## **Access Compliance Report Public Rights-of-Way** (Curb Ramps)

Intersection ID: 15991 Main Street: BUNCHE DR **Cross Street: WHEATLEY AV** Location: NW ADA ID: BA38661399FD Ramp Type: PerpDiag Initial Pass/Fail: Fail **Overall Compliance: No** Severity Score: 13.75

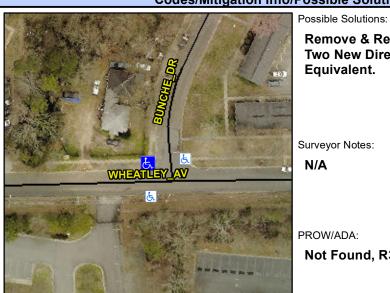
Not Found, R304.2.2, R304.5.3

Compliance Description		Data	Comp	liance Description	Data
N/A	Ramp Length (in)	28.0	No	Ramp Slope (%)	9.1
Yes	Ramp Width (in)	48.0	No	Ramp XSlope (%)	3.0
N/A	Flare Type LT	N/A	N/A	Flare Type RT	N/A
N/A	Flare Slope LT (%)	N/A	N/A	Flare Slope RT (%)	N/A
N/A	Flare Traversable LT?	N/A	N/A	Flare Traversable RT?	N/A
N/A	Landing Length (in)	N/A	N/A	DWS Provided?	N/A
N/A	Landing Width (in)	N/A	N/A	DWS Contrast?	N/A
N/A	Landing Slope (%)	N/A	N/A	DWS Length (in)	N/A
N/A	Landing X Slope (%)	N/A	N/A	DWS Full Width?	N/A
N/A	Landing Curb? (Y/N)	N/A	N/A	DWS Offset (in)	N/A
N/A	Shared Landing?	N/A			
N/A	Gutter Ponding?	N/A	N/A	Gutter Slope (%)	N/A
N/A	Gutter Lip Ht (in)	N/A	N/A	Gutter X Slope (%)	N/A
N/A	Painted X Walk1?	No	N/A	Painted X Walk2?	No
	X Walk 1 Direction	To SE		X Walk 2 Direction	To NE
N/A	X Walk 1 Width (in)	N/A	N/A	X Walk 2 Width (in)	N/A
	X Walk 1 Slope (%)	7.3		X Walk 2 Slope (%)	6.3
	X Walk 1 X Slope (%)	6.8		X Walk 2 X Slope (%)	1.5

Two New Directional Ramps or Equivalent. Surveyor Notes: N/A

Remove & Replace Curb Ramp With
